**Lauderhill City Center
Responses to Statement of Information Needed
(First Round)**

Submitted on behalf of:

LM TIC I LLC, LM TIC II LLC, LM TIC III LLC, LM TIC IV LLC, and LM IDEAL, LLC,
LM TIC I LLC, LM TIC II LLC, LM TIC III LLC, LM TIC IV LLC, and LM IDEAL, LLC

December 19, 2008

Map A - General Location Map

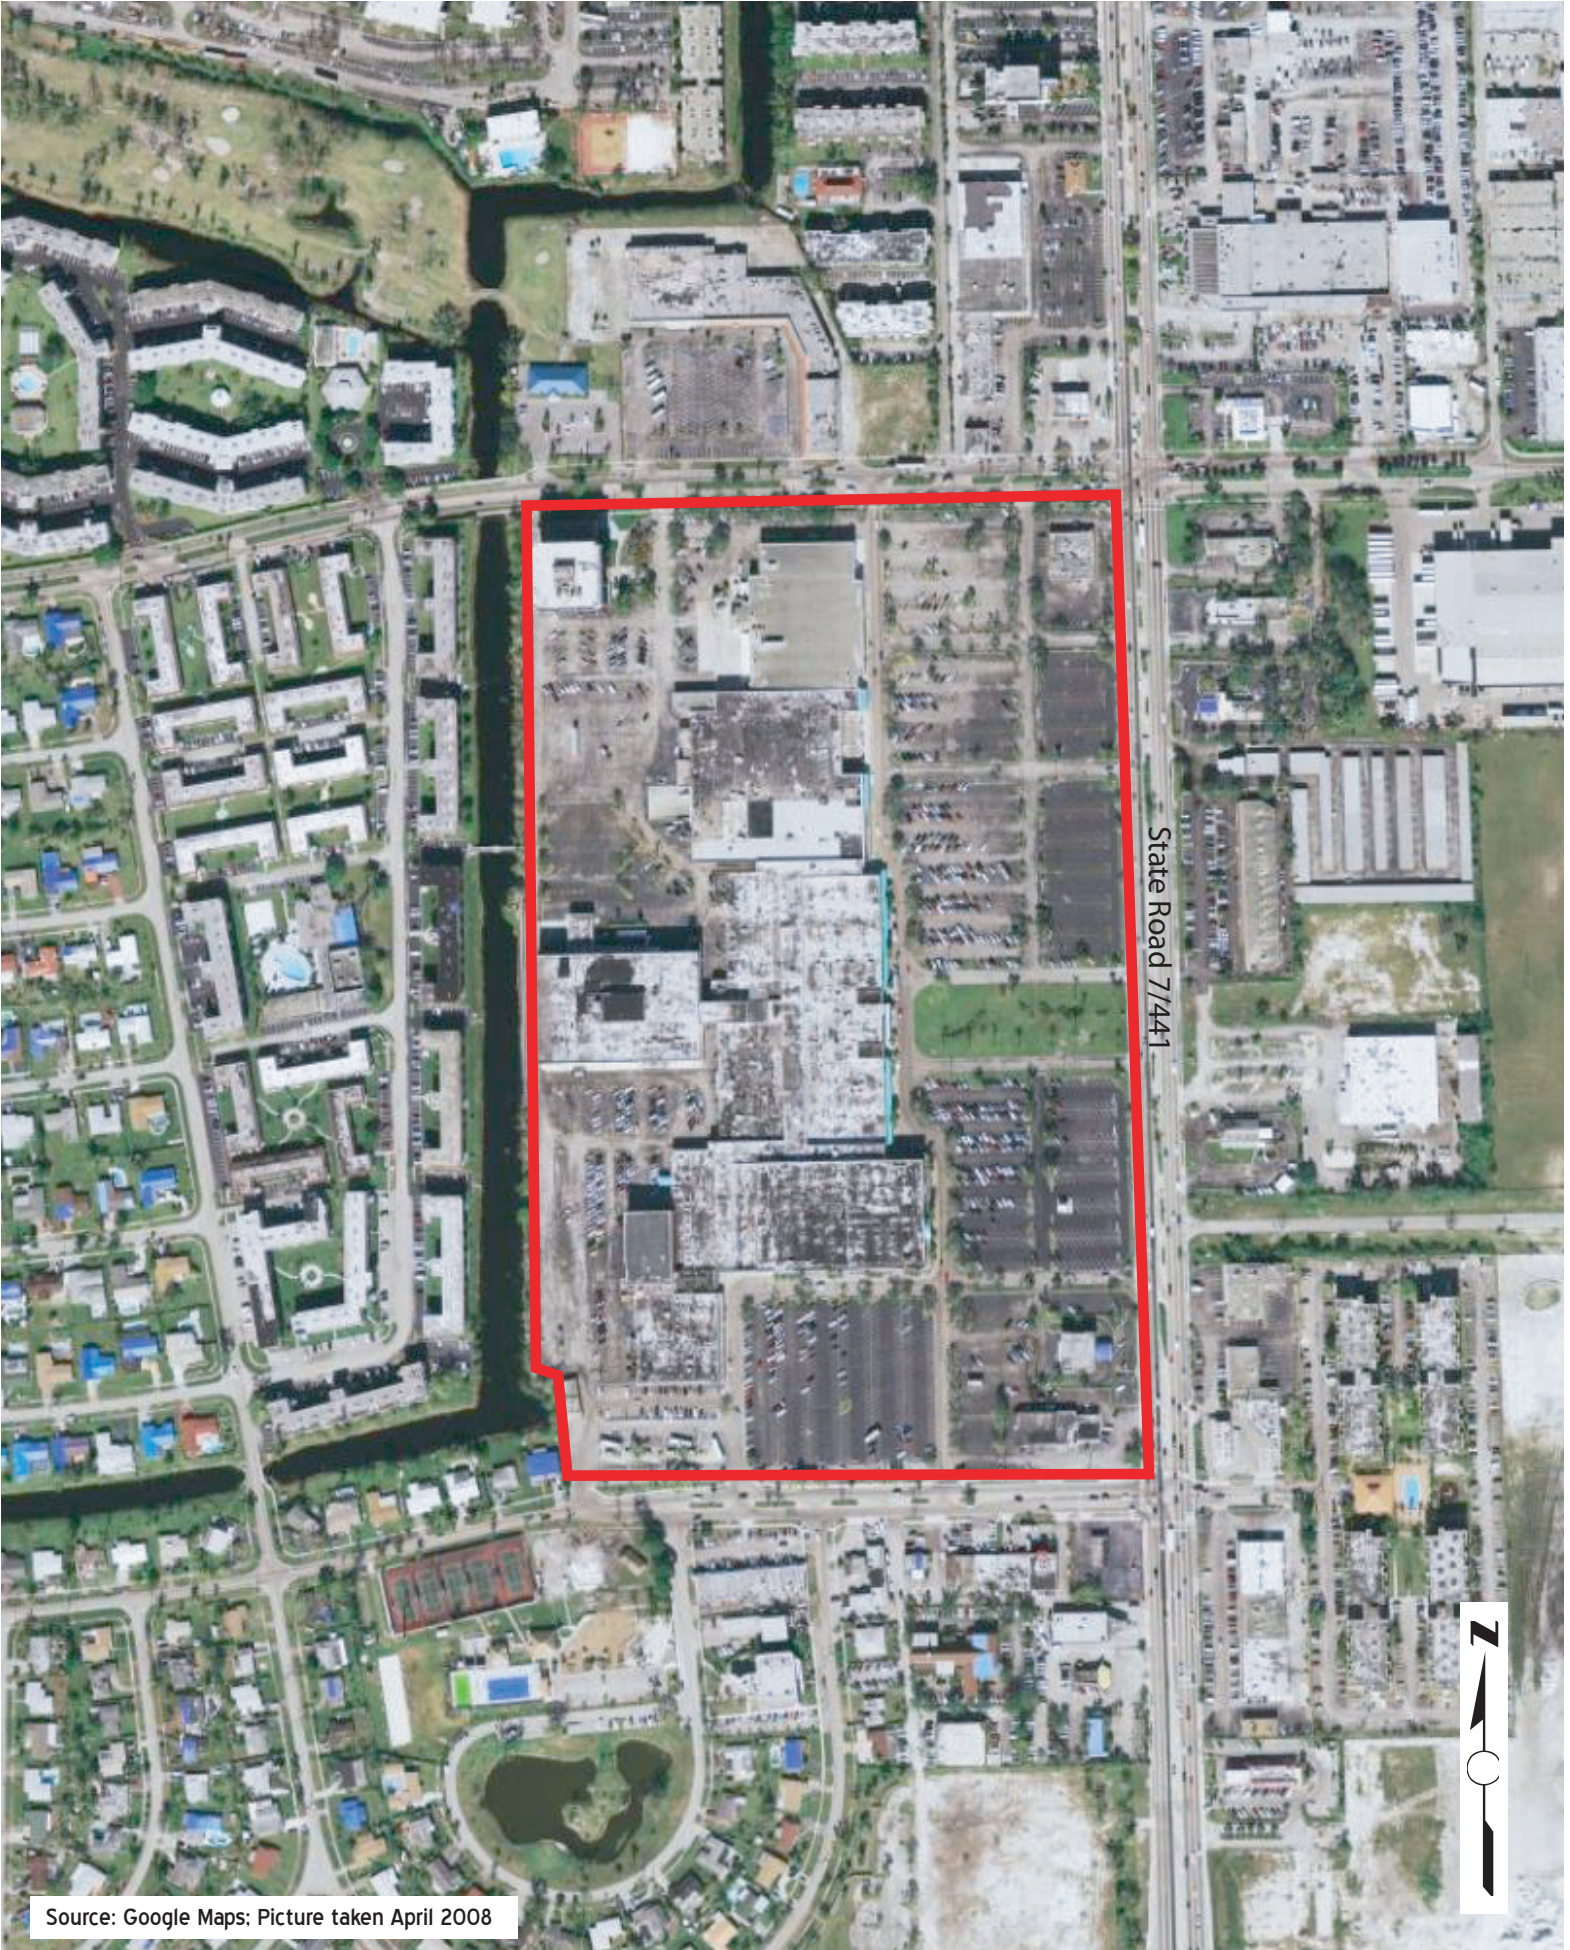
Comment: The Applicant's response appears to be insufficient because the noise contour maps are illegible. Please resubmit in a large size so that the text is readable. In addition, please label major roadways on General Location Map.

Applicant's Response: *Larger noise contour maps have been attached as Composite Exhibit H. The revised General Location Map has been attached as part of Composite Exhibit A.*

Map D.1 - On Site Land Uses

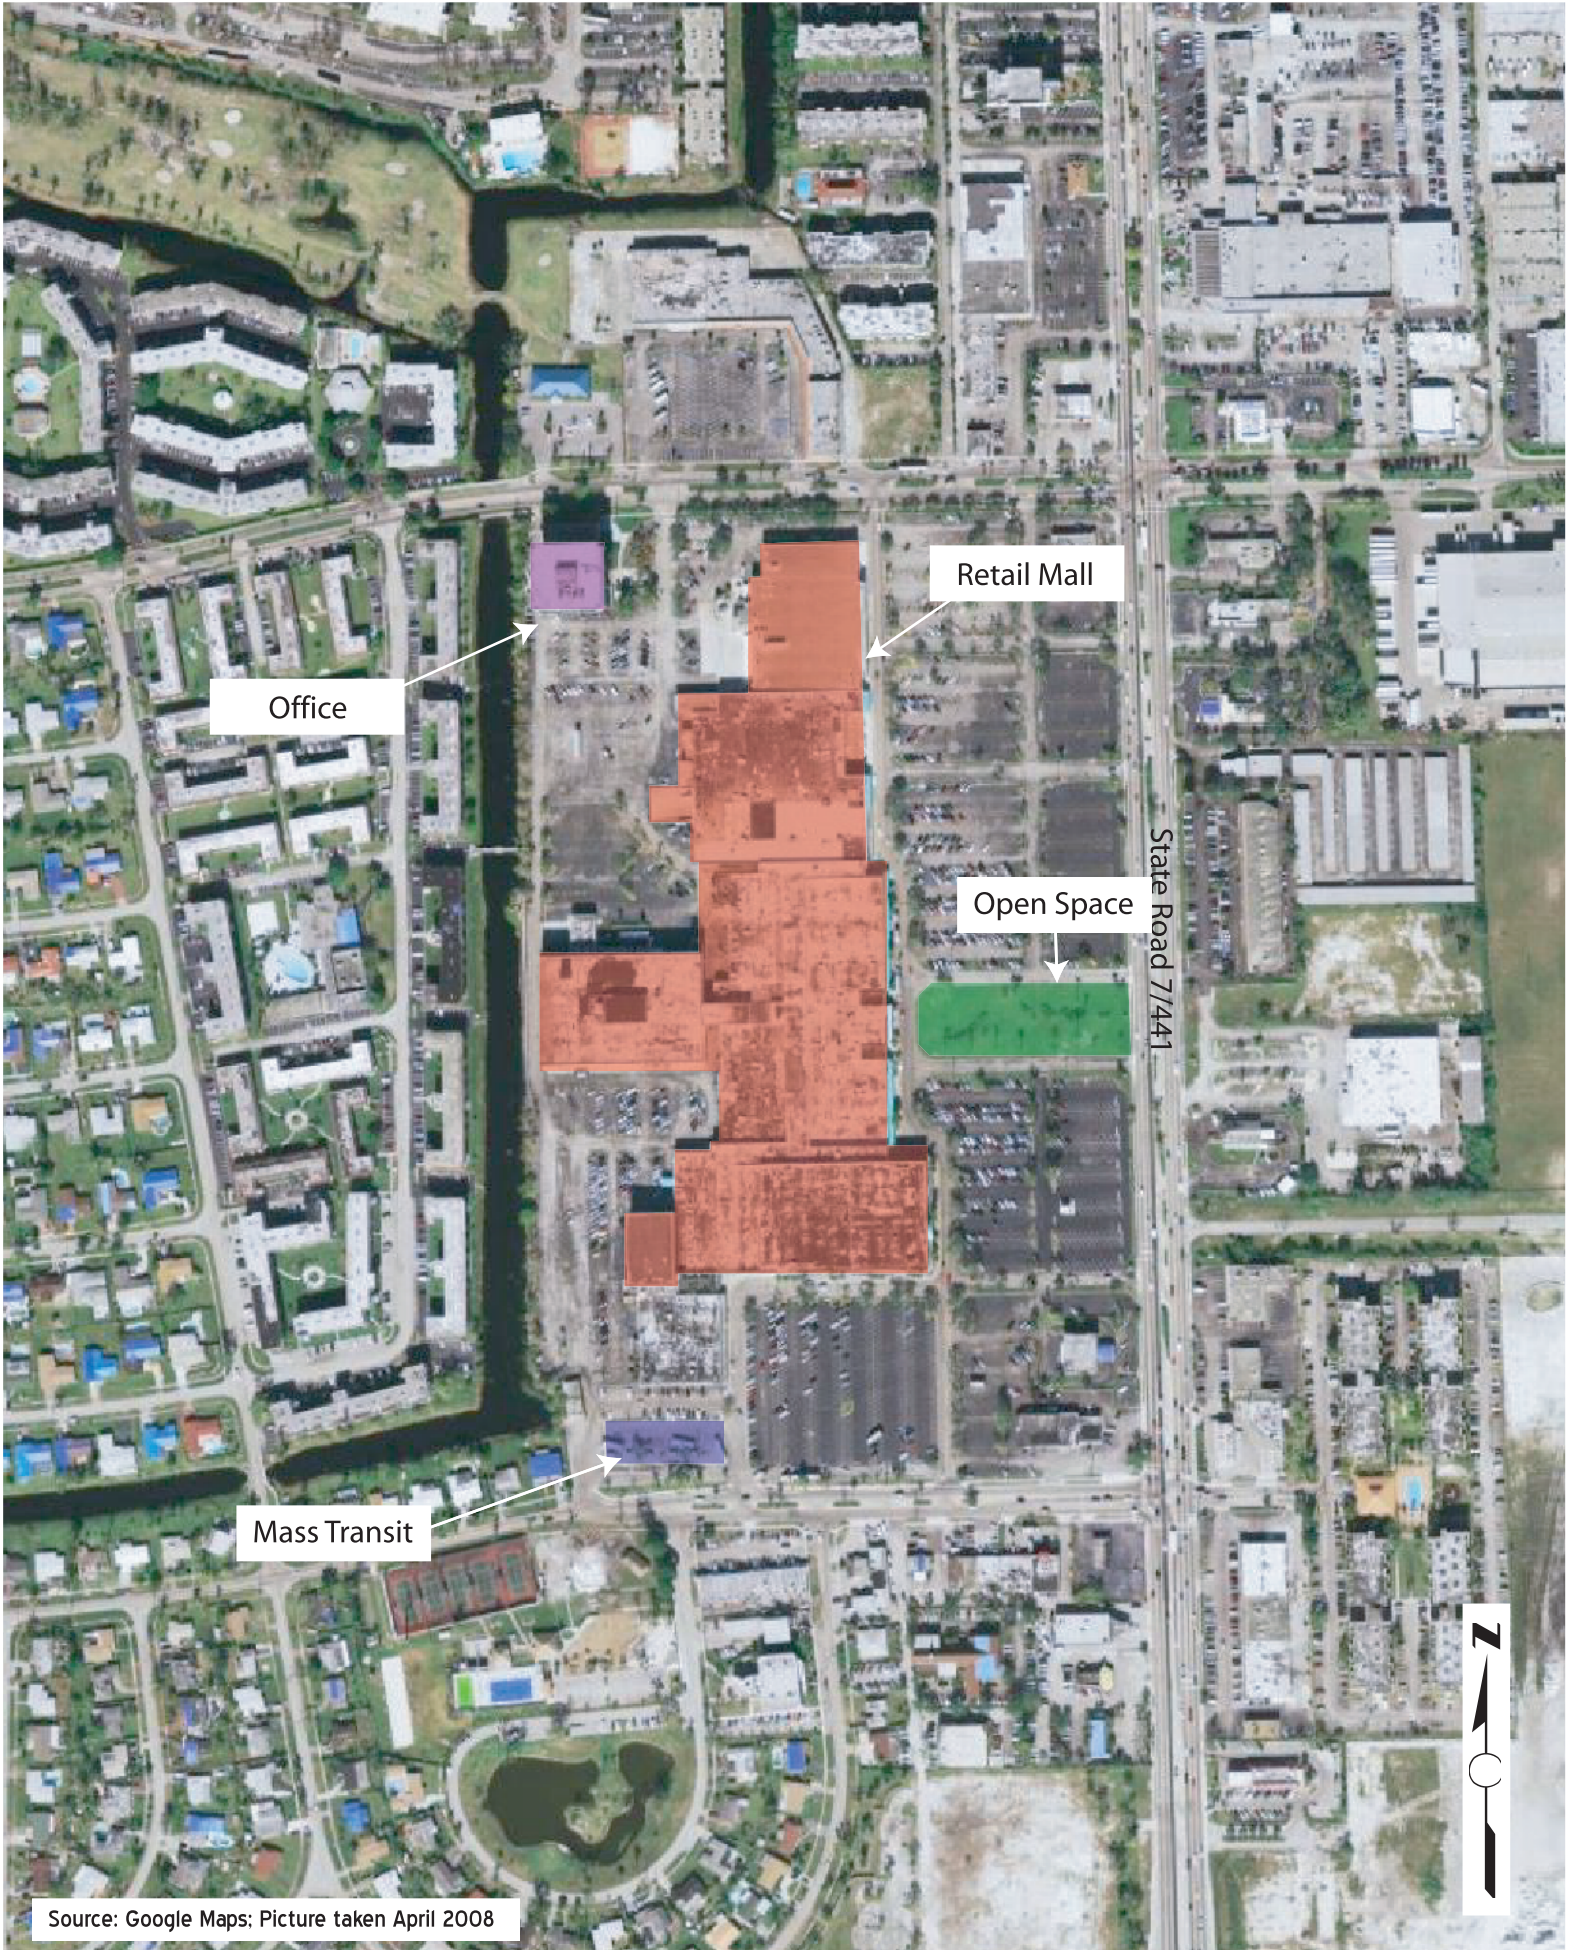
(a) Map D. An aerial photograph is offered as the required land use map. The land use map must show existing and approved uses on and abutting the site. The aerial photograph shows the building configurations abutting the site but not the abutting existing and approved uses, The land use map also must show existing on-site land uses but the aerial photograph does not display these uses, The land use map should show, at a minimum, the following on-site land uses: an office building, a retail mall, a public transit station, and open space, in addition, utility and drainage easements are required to be displayed but are not shown on the map. Thus, it is recommended the ADA be amended to add this information.

Response: *The maps have been revised in accordance with the foregoing comments. Please note that Map J has been updated with bus terminals. We feel that the boundaries have been clearly indicated and include: Commercial Boulevard to the north, Andrews Avenue to the east, Interstate 595 to the south, and Nob Hill Road to the west. Regard Map D, the land use map has been revised to show abutting uses. Map D.1 has been created to show on-site uses. All of revised maps are attached as Composite Exhibit A.*

Map D - land use map

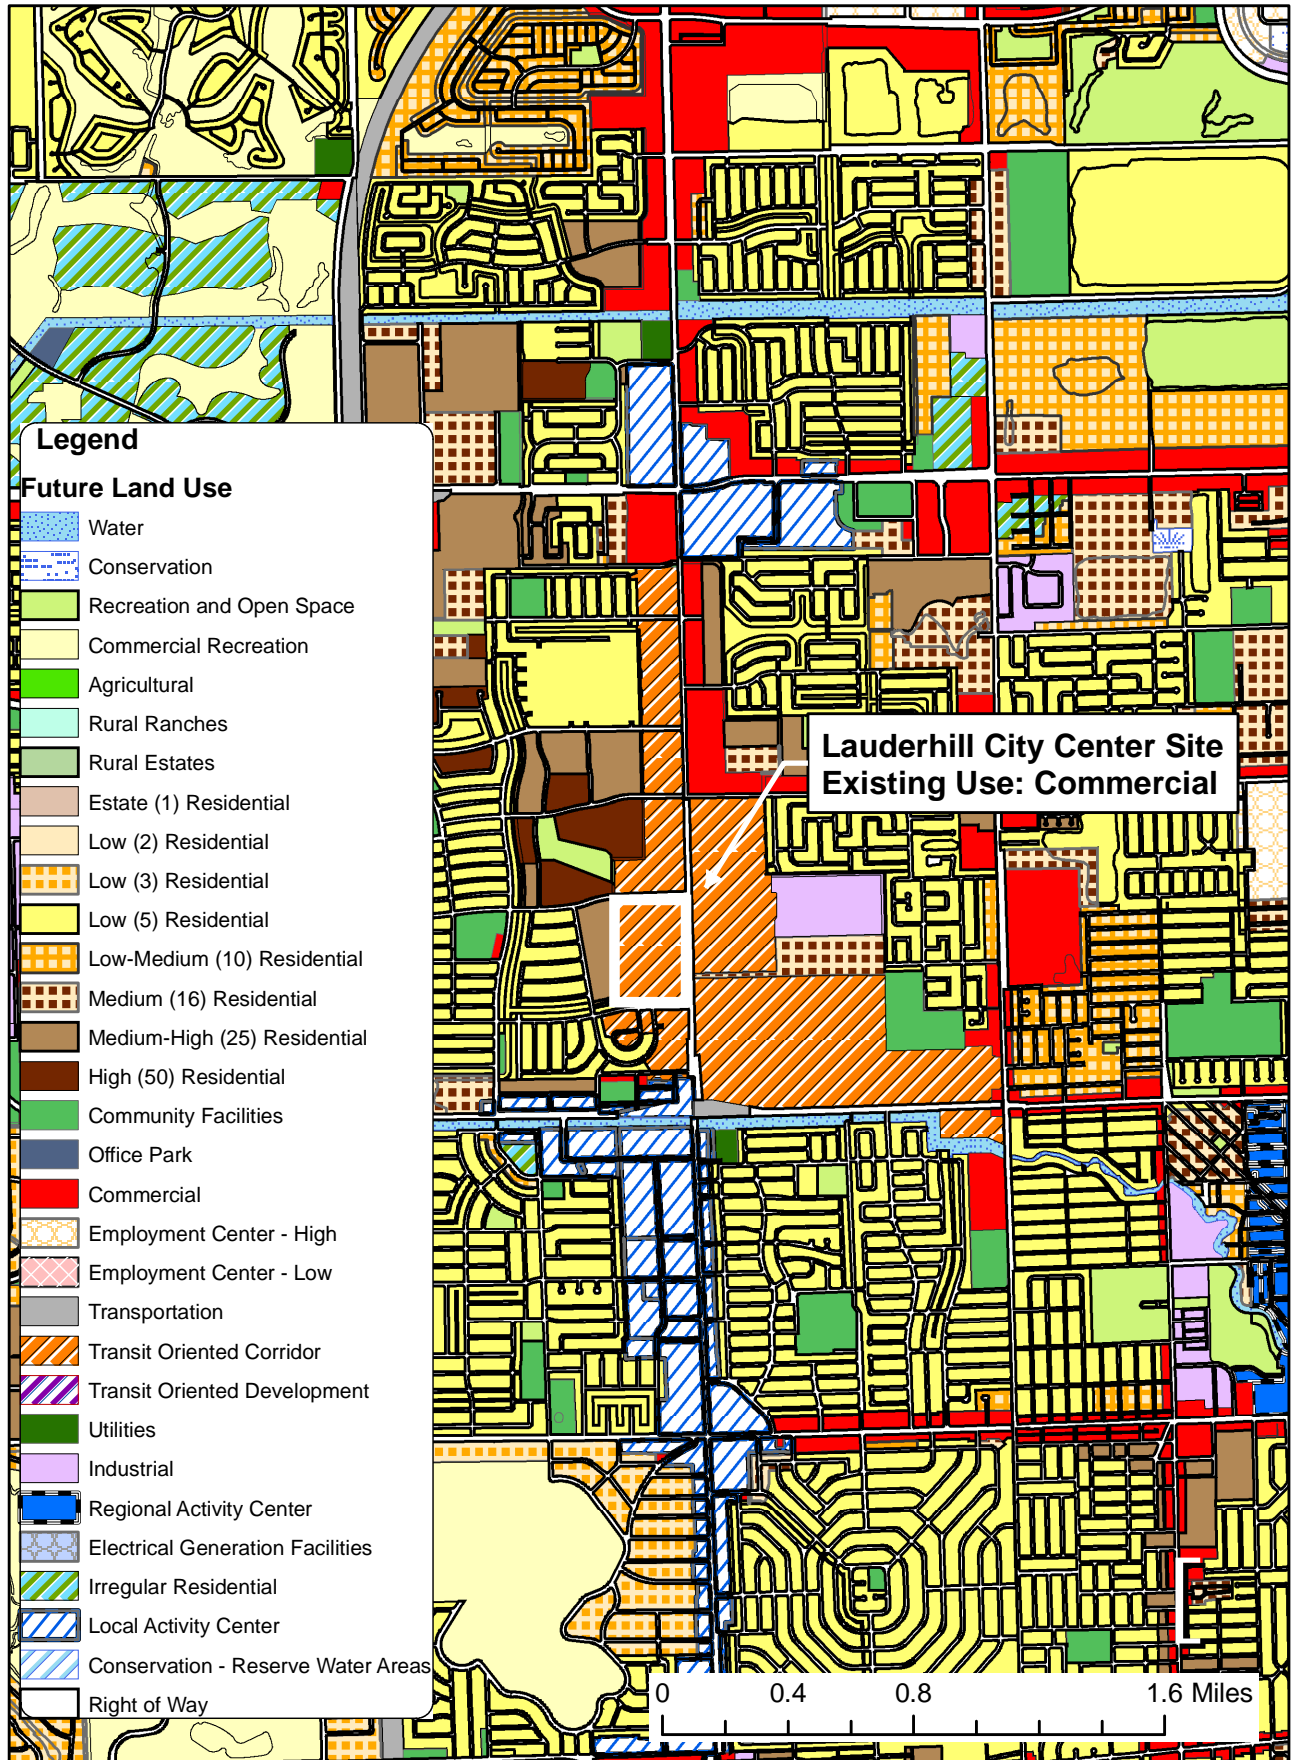
- Map D shows adjacent future land uses but does not delineate their boundaries as shown on the adopted Future Land Use Map (FLUM) from the City of Lauderhill Comprehensive Plan. The map should include existing on-site land uses, recreational areas, utility and drainage easements, wells, right-of-way, and historic, archaeological, scientific and architecturally significant resources and lands held for conservation purposes.

Applicant’s Response: *Maps A, B, H, Ia, and Ib have been revised in accordance with the foregoing comments and are attached hereto as Composite Exhibit A. Please note, however, that the Applicant does not see any inconsistencies between the out boundary as depicted on Map H and that as shown on Maps Ia and Ib. Moreover, the scale level at which the transportation network is depicted on Map J-12 makes it impossible to represent the location of the two driveways at the green space along SR 7/U.S. 441.*
